CONCESSION				Reference	TN-006536486
CONCLOSION					C FW
Drawing N°	V53274233			Revision	
Part N°	V53274233008	Quantity	1	Page	1 of 2
Part Description	Part Description SSRH CDS FRAME INSTL			A/C Type	A350-900
Item SN	N/A	CA code and s/n	WG540/TN10806	MSN	00794
		Responsible Design Office Decision Acceptable after further work performed		Attached documents	3 pages

TN-006536486

SSRH CDS FRAME INSTL

1

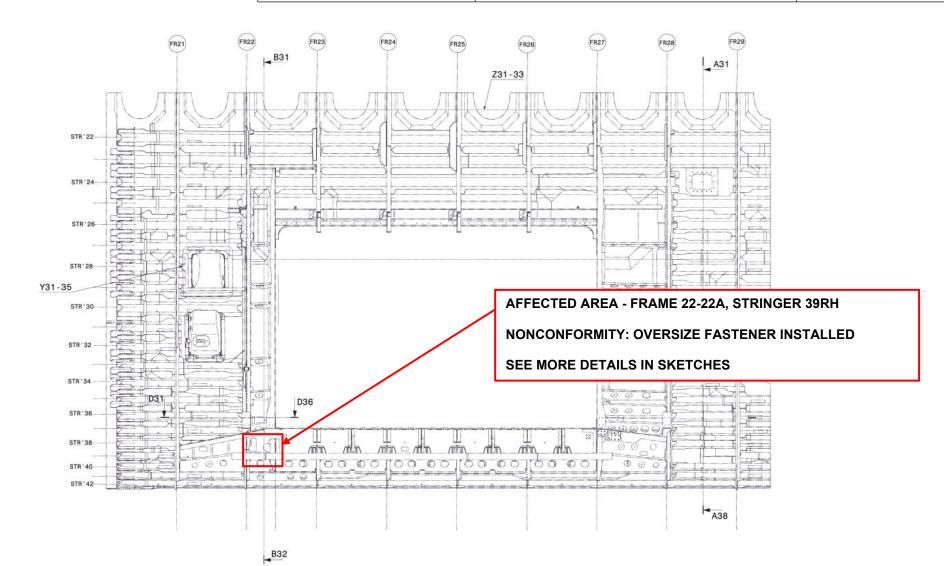
Location:FUSELAGE

SECTION 13/14,ON LOWER PART,STRUCTURE,RIGHT SIDE,EXTERNAL SURFACE

From Frame 022 to 022A, Stringer 39

Type of nonconformity: Oversized Hole

Drilled Hole Specification : ABS1707EP1V3AX
Nominal Pitch & Edge Distance : Yes (see Sketches)
NONCONFORMITY: OVERSIZE FASTENER INSTALLED

- Acceptable after further work performed

2

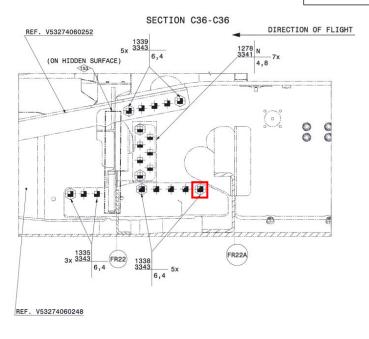
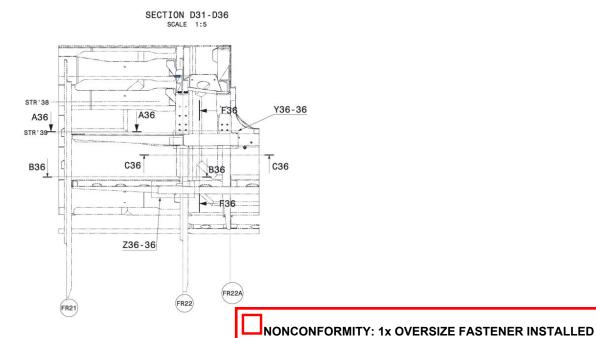
REPLACE EXISTING TEMPORARY FASTENER

NOMINAL: HOLE CODE: ABS1707DP1V3A

FASTENERS: EN6115B4E + ABS1826K4

ACTUAL:

HOLE CODE: ABS1707EP1V3AX

FASTENERS: EN6115B5X + ABS1826K5

FASTENER POSITION, EDGE DISTANCE, PITCH DISTANCE AND

AFFECTED PARTS THICKNESS AS PER DRAWING.

3

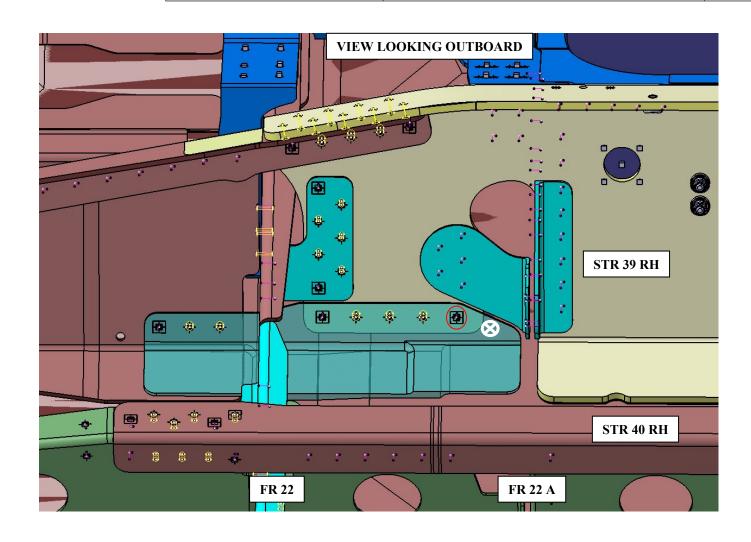
- Concession marking to be preformed as per sketch 3 for Nonconformity 0001.

- PERMANENT MARKING (CONCESSION REFERENCE) AS SHOWN ABOVE. MARKING WITH LABEL TYPE NSA 9117-05 OR INDELIBLE INK. REF AIPS07-06-007 AND AIPS08-03-002.
- PROTECT THE MARKING WITH VARNISH ACCORDING TO AIMS04-04-022 AS PER AIPS07-06-007.
